UDRP Comments and Applicant Response

Urban Design Review Panel Comments

Date	December 12, 2019	
Time	2:00	
Panel Members	Present Janice Liebe (Chair) Robert Leblond Terry Klassen Chris Hardwicke	Absent Chad Russill (Co-Chair) Gary Mundy Amelia Hollingshurst Yogeshwar Navagrah Jack Vanstone Ben Bailey Bruce Nelligan Glen Pardoe (recused) Eric Toker
Advisor	David Down, Chief Urban Designer	
Application number	PE2018-01104	
Municipal address	8610 Horton Rd SW	
Community	Haysboro	
Project description	Pre-Application for a Proposed Development	
Review	first	
File Manager	Ezra Wasser	
City Wide Urban Design	Lothar Wiwjorra	
Applicant	NORR Architects, Engineers, Planners	
Panel Position	Endorse / Further Review Recommended

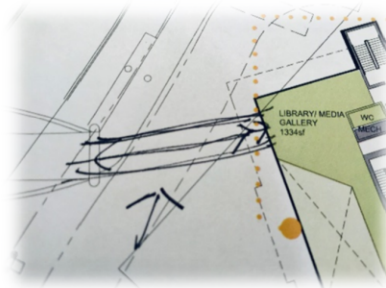
- b) The Panel recommends functional design assessment of the bridge extending directly into what is currently shown as the Library/Media Gallery on the Level 02 Amenity Floor (see sketch notation below.)

1 b)- The request made for connection to the Pedestrian Bridge on City-owned land is not a recommended solution for the site from a programmatic or security perspective. The Pedestrian Bridge is located outside of the property line and connects for a larger number of public users to cross over Horton Road and the train line. From a security standpoint, this interface is not coordinated to the main building entrance and program, and safety is of utmost concern for the resident demographic.

Concerns also lie with the bridge's existing foundations and structure in addition to maintenance of the existing structure and repairs.

To summarize, our team is of the position there is adequate connection to the public realm along Horton Road to satisfy pedestrian connectivity for this permit application; sidewalk upgrades along Horton/Hull Ave may be required to emphasize this connection, to be further discussed with the City during the review period.
